No. 99-10

## Tilt Release – Big Foot 50 (4S) & 60 (2S)

**Power Trim with Cylinder Removed**

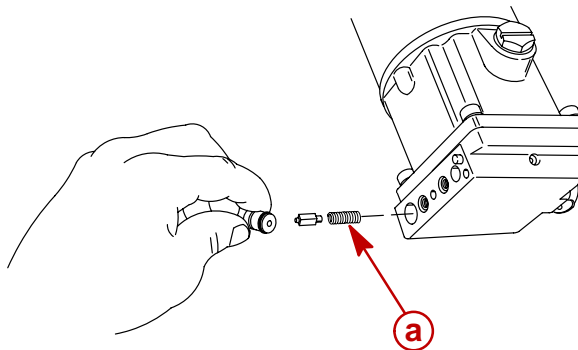
Some customers with big foot models have become concerned when they can easily push their unit down by hand from the full tilt position. This is usually experienced on dry land while cleaning or servicing. The design of the power trim allows this to occur mostly due to the geometry of the tilt system, internal valving, and the additional weight of the big foot gear-case. Complete power trim units have been replaced in an attempt to “fix” the problem, without success. The power trim is operating as designed.

Outboards after the serial numbers listed have the new stronger power trim tilt release spring p/n 24-804849 to prevent the “easy tilt down” from occurring as a product improvement. Customers may have the new inexpensive tilt release spring installed, at their own expense, if they desire. Labor to install the new spring is approximately one hour.

The tilt relief spring color is also changed from the previous plain steel (dark) color to the new silver (galvanized) color. The new spring is also contained in the Trim Limit Valve Kits 809873A2 with date on or after 27 Aug 98.

Replace the existing dark colored tilt release spring in the power trim manifold with a new silver spring p/n 24-804849.
